## Specific Design Plan Balmoral, Lot 13 Block A

## SDP-0609-H8

SUBJECT: Homeowner's Minor Amendment to Specific Design Plan SDP-0609-H8  
Balmoral, Lot 13 Block A

**SITE AND ELEVATION DETAILS – SITE SURVEY AND LOT COVERAGE CALCULATION**

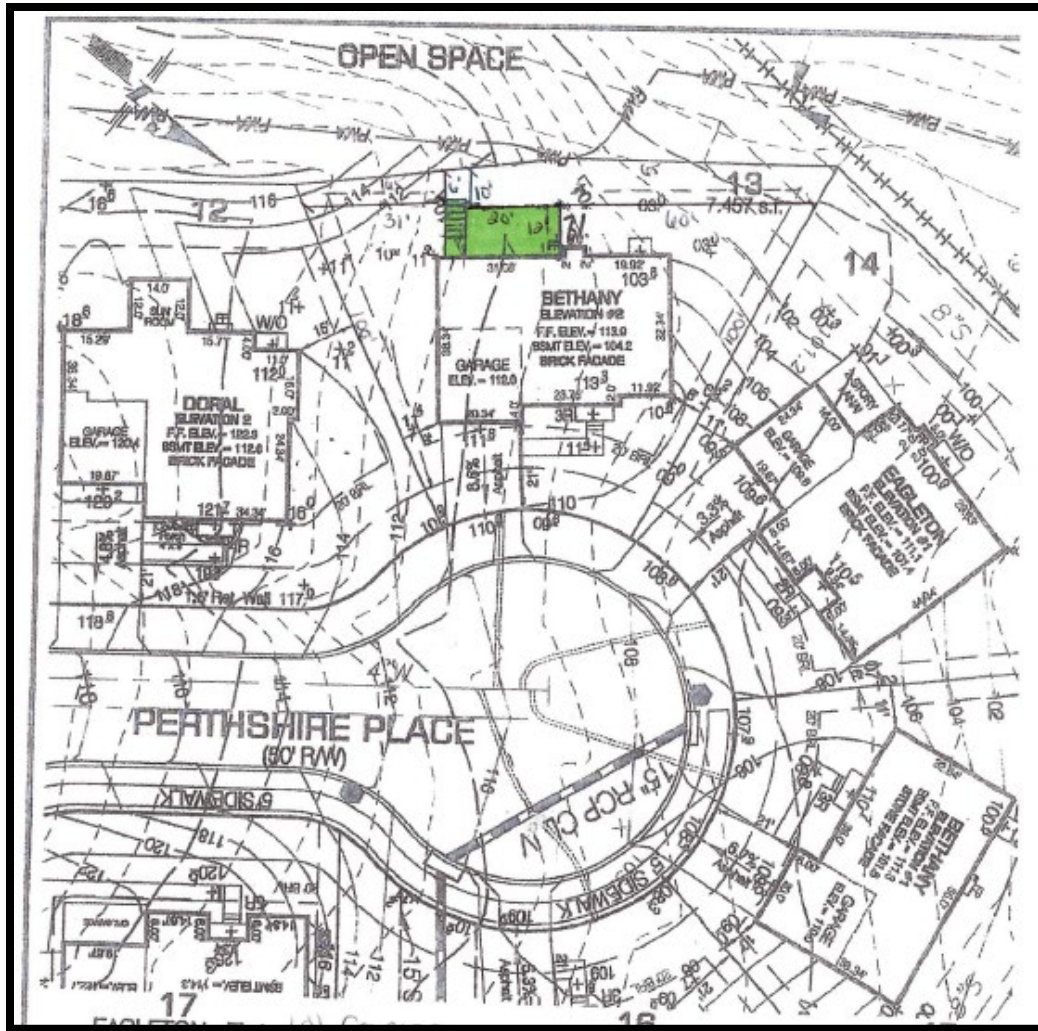
9. **Comprehensive Design Plan CDP-0302:** The project complies with the requirements of CDP-0302. The CDP stipulates that the minimum rear yard setback for single-family detached houses is 15 feet. The proposed elevated screened porch would be approximately 10 feet from the rear property line, encroaching 5 feet into the rear setback.

SDP-0609 established the rear yard setback at a minimum of 15 feet. The proposed elevated screened porch addition extends into this rear yard setback by 5 feet, proposing a setback of approximately 10 feet from the rear property line. The subject application does not meet Criterion (A). Therefore, the subject Homeowner's Minor Amendment to SDP-0609-H8 is to be heard by the Planning Board, as stated in Section 27-530(d)(3)(A) of the prior Zoning Ordinance.

# SITE AND ELEVATION DETAILS – ARCHITECTURE

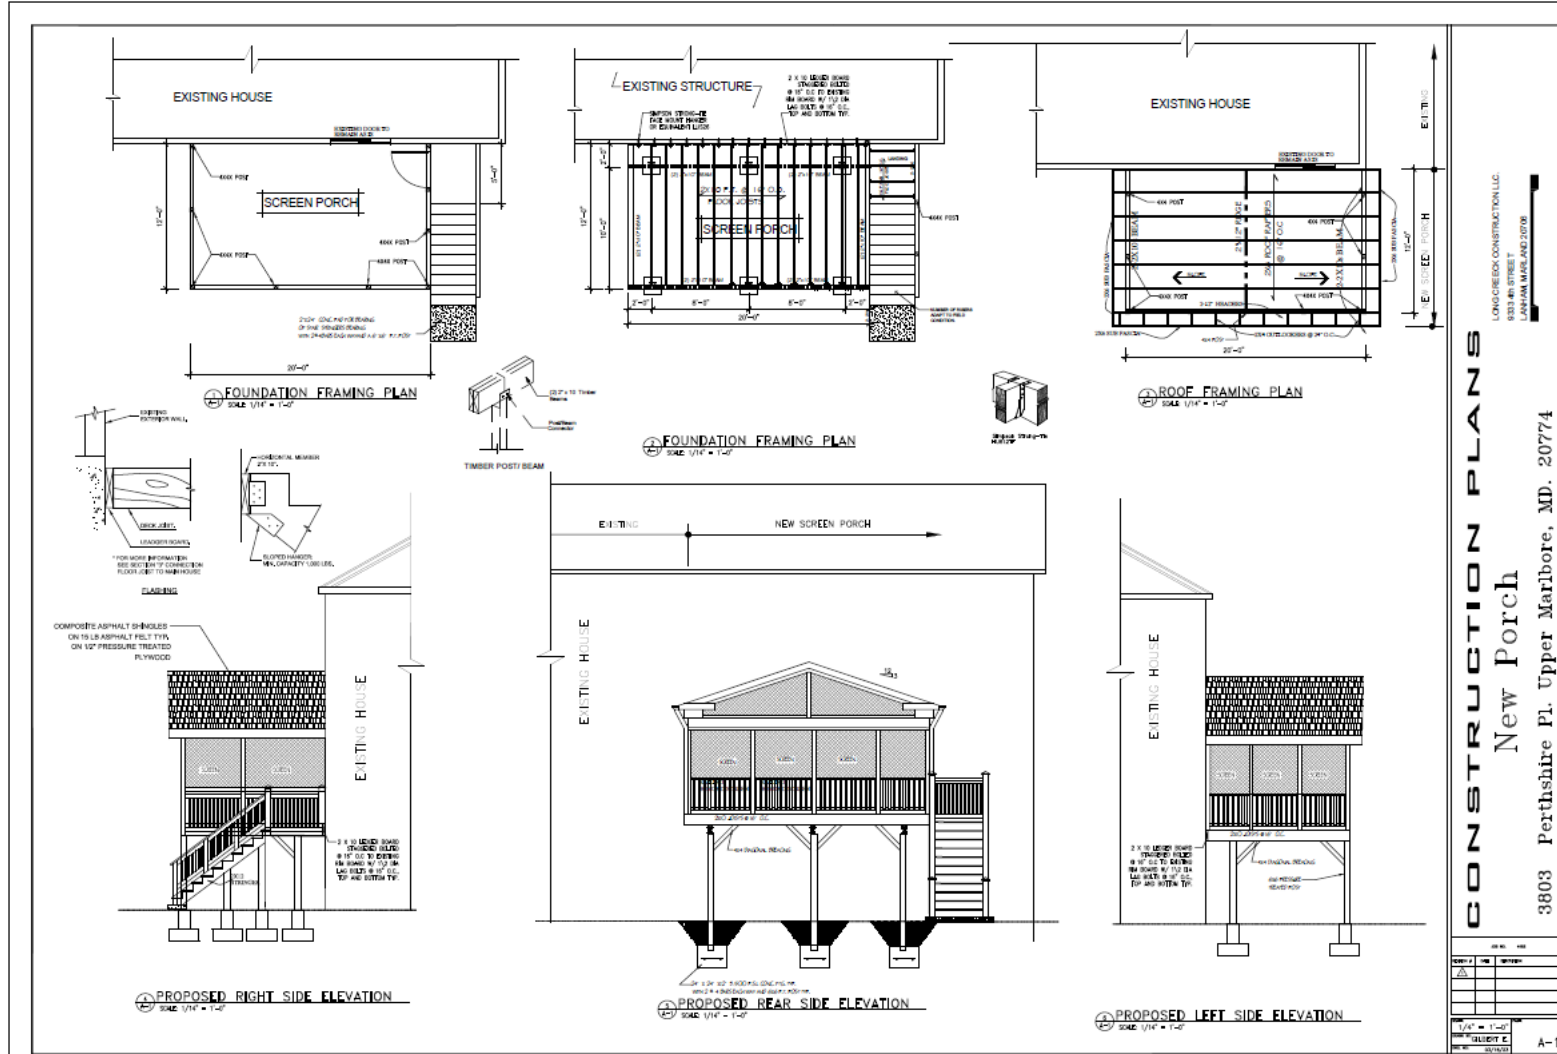
Regarding Criterion (B) above, the proposed elevated deck addition is consistent with the architectural and site design characteristics of the approved SDP, except regarding the rear yard setback. The proposed screened porch will be constructed of wood, with a white vinyl railing system and white vinyl wrap posts and beams, with a screened enclosure. The proposed screened porch and roof of the enclosure will be in keeping with the existing architectural and site design characteristics of the SDP, in materials and design.

1. Prior to certification, both the left, right, and rear architectural elevation shall be dimensioned with the appropriate height and width of the proposed addition.
